Joint scheduling of driver activities and charging for long distance electric truck operation under travel time uncertainty

Editorial annotation layer — read this first

This build of the paper carries a review layer on top of the author text. Nothing of the original wording has been silently changed: every intervention is colour-coded.

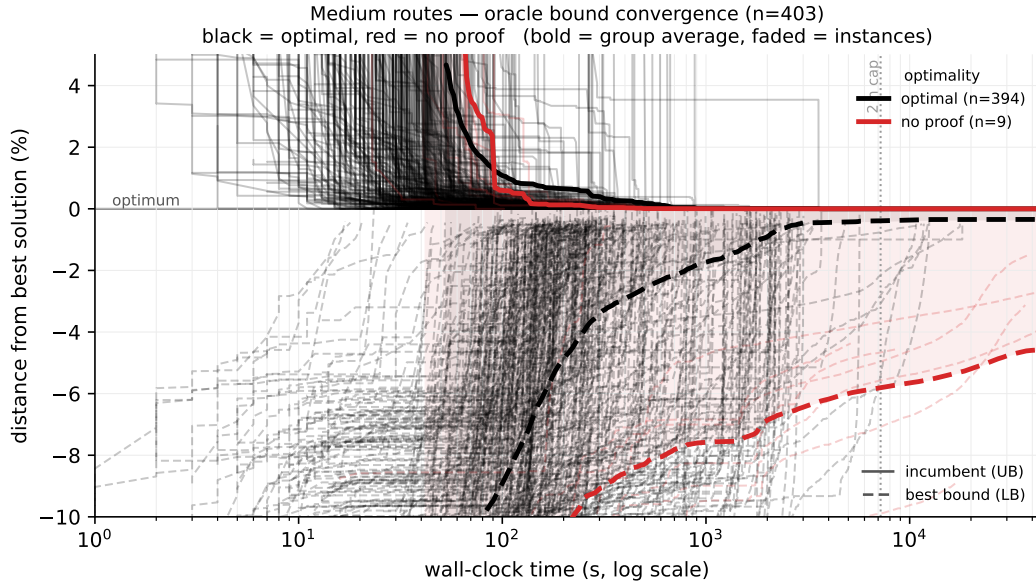
The manuscript deleted the oracle-convergence figure but kept the claim. Either restore `figures/oracle_bounds_opt_*.pdf` (they exist in the repository) or drop the “roughly half” quantifier, which is currently unsupported by anything the reader can see. Restored below as Figure 5; it costs a third of a page and it is what licenses every gap in the paper.

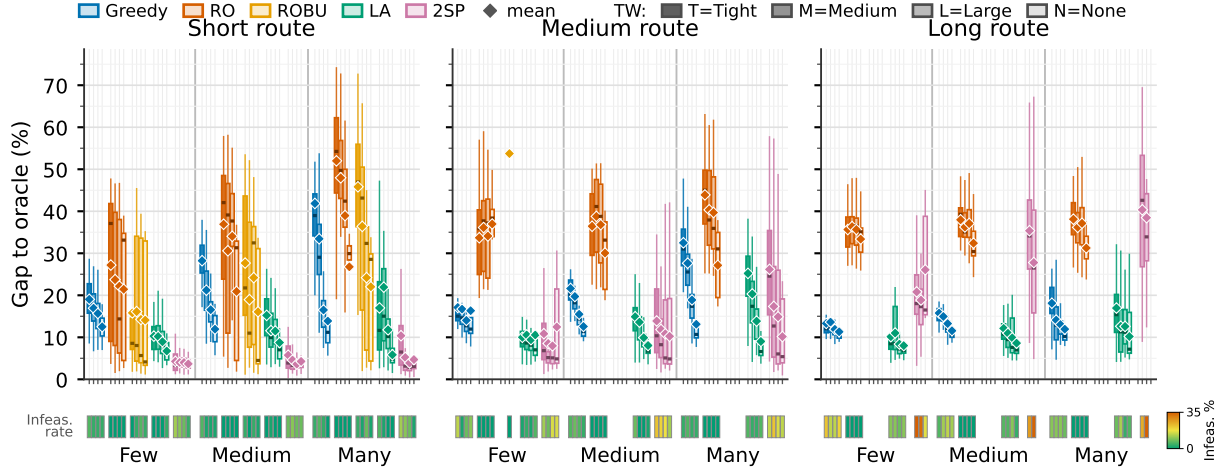
Figure 6 — four fixes. (1) The infeasibility strip uses a green→orange ramp that collides with RO’s vermillion and ROBU’s orange in the method palette. Use a single-hue sequential ramp no method owns. (2) Empty slots are silent; annotate them “no runs” so absence is not read as zero. (3) The four TW shades are indistinguishable at print size — consider dropping to two levels (Tight / None) in the main figure and moving the full grid to the appendix. (4)

Annotate n per box, or at least mark the boxes with $n < 20$: the reader currently cannot tell a 50-seed box from a 5-seed box.

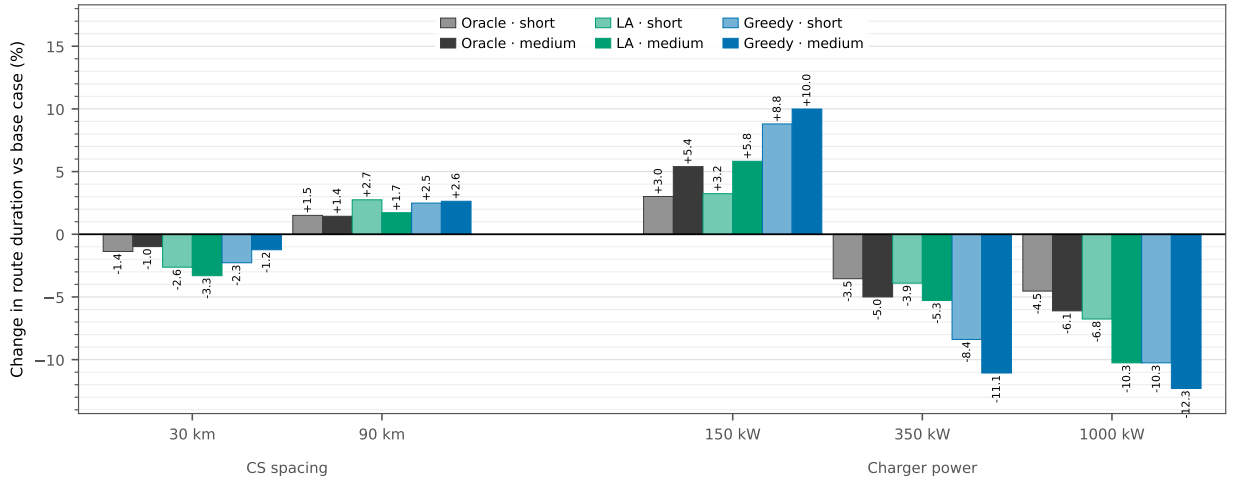
Figure 7: the x tick labels are horizontally offset from their bar groups (the “30 km” label sits to the left of its group), and the in-figure legend duplicates information that the caption

could carry. Also consider plotting the oracle bars against a zero line with the policy bars as translucent overlays, so the reader sees at a glance that the policies *amplify* the problem's response rather than merely tracking it.

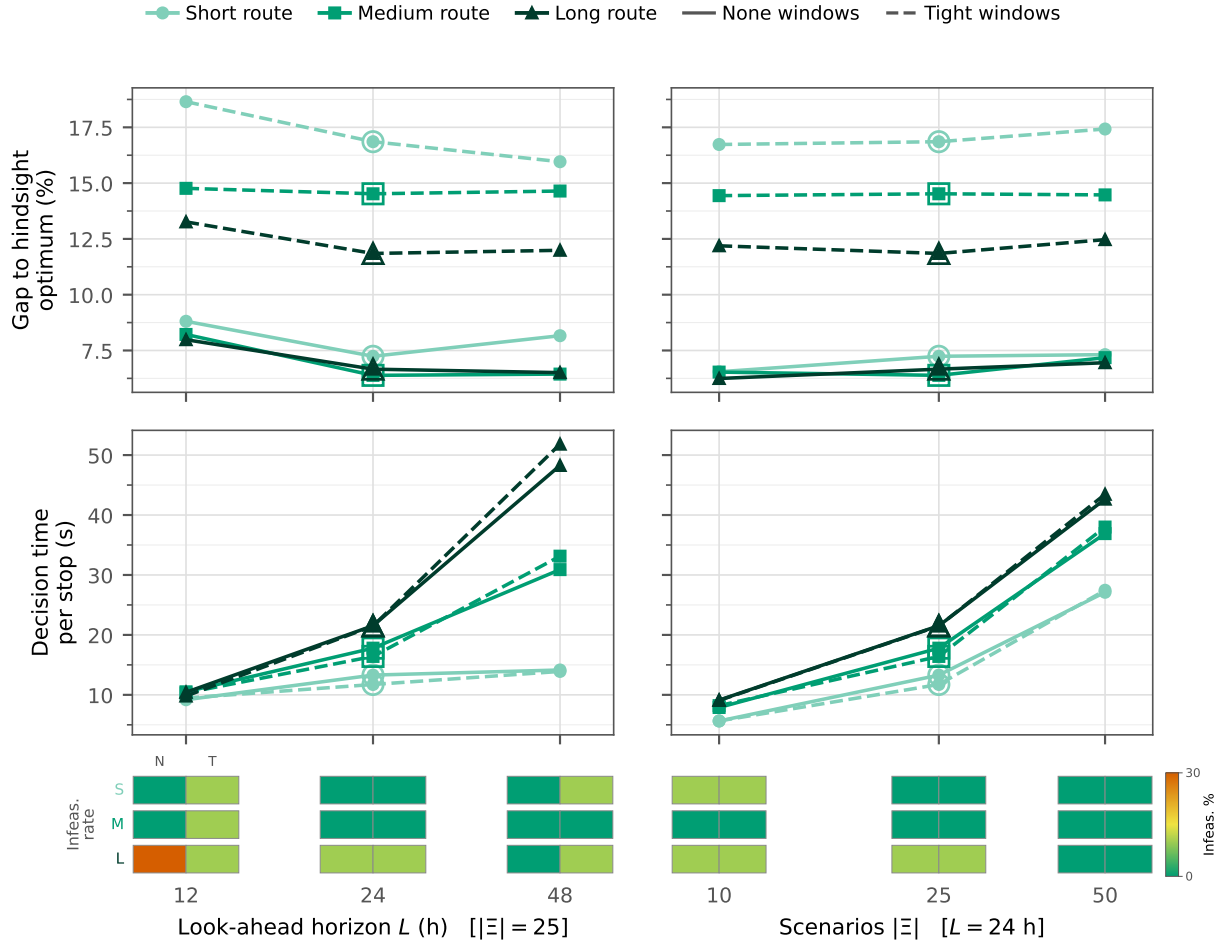
Two caption/figure mismatches carried over from `results_section.tex`, now corrected above but the *figure* still needs fixing: (i) the caption promised “dotted verticals marking the 13 h regular spread and the 24 h duty cycle” — they are not drawn, and they should be, because they are the whole argument of the “why these horizons” paragraph; (ii) the caption promised a logarithmic decision-time axis — the axis is linear. Also: the route-class ramp is drawn in *green*, which is LA’s method colour in `paper_style.py`, violating that module’s own rule that route class uses the ordered blue ramp. Two encodings currently collide.

Figure 9: The same five cells plotted as cost against quality, one panel per route class. The two ladders leave the base cell in different directions; the steeper path identifies where an additional second of per-decision compute is better spent.

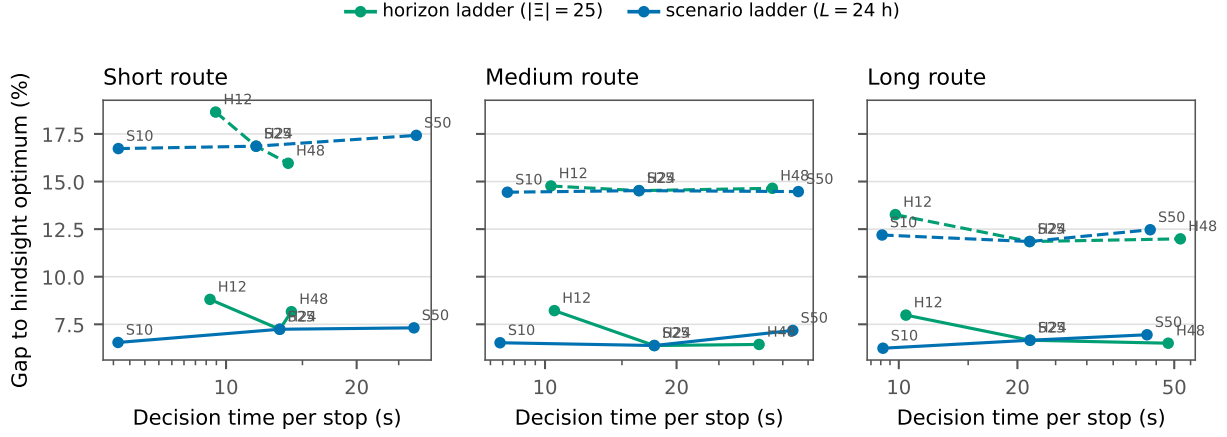
Figure 9: the base-cell labels H25 and S25 overprint into unreadable glyphs; the solid/dashed window distinction has no legend entry; and green/blue for the two *ladders* again collides with the method palette (green = LA, blue = Greedy). Recommend a neutral pair, e.g. the ordered ramp, with markers rather than colour distinguishing the ladders.

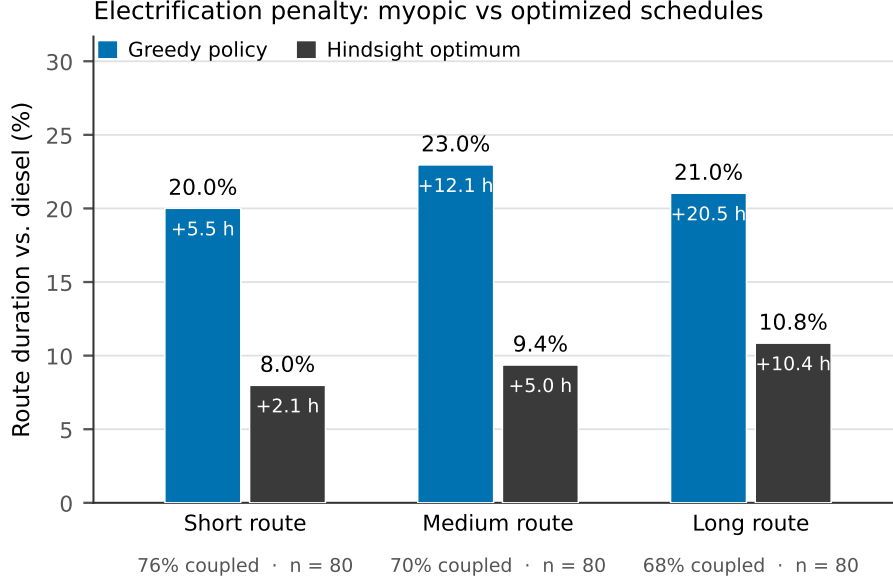
The manuscript caption describes three bars including a “naive estimate (diesel makespan plus the EV’s total charging time)”; the figure has two. Corrected above. [TO DO: the naive-estimate bar would actually be worth adding back — it is the quantity a practitioner would compute, and showing that the realized optimum beats it by the coupling credit is the clearest possible statement of what break/charge synchronization is worth.]

Figure style: this figure and Figure 11 carry in-figure matplotlib titles that duplicate the L^AT_EX caption, while no other figure in the paper does; and Figure 11 draws the oracle in pure black whereas Figure 10 uses the `paper_style.py` neutral grey #3A3A3A. Route both through `METHOD_COLOR` and strip the titles.

Figure 11: Electrification penalty by time-window class. The optimized penalty rises monotonically as windows loosen; the myopic one does not respond to windows at all.

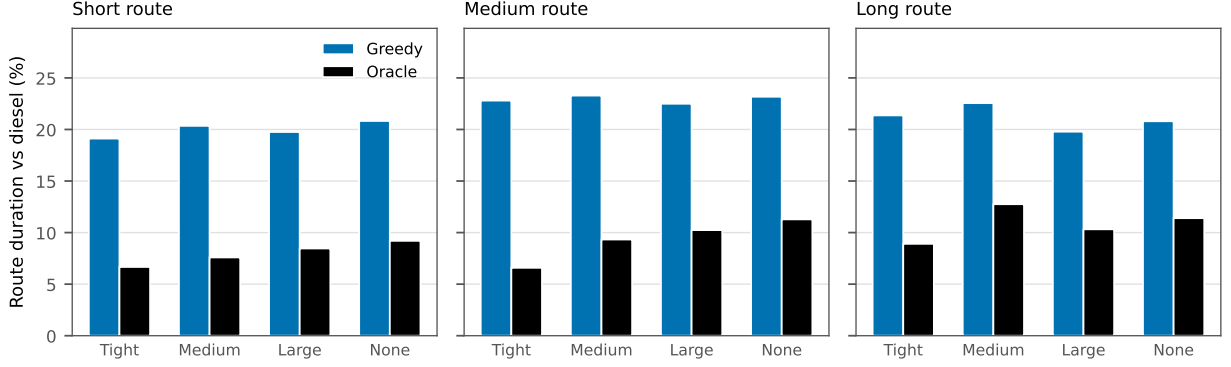
Missing from the manuscript: the mechanism behind Figure 11, which is counter-intuitive and therefore worth the space.

This finding depends entirely on assumption A3 (no idle waiting) — which is precisely why A3 must be stated in Section 3 rather than left in the code. If waiting were free, the diesel

would absorb its early arrival at zero cost and the trend would vanish. Say so explicitly: it is an honest limitation and it makes the result more interesting, not less, because “no idle waiting” is the realistic assumption for a driver whose clock is running.
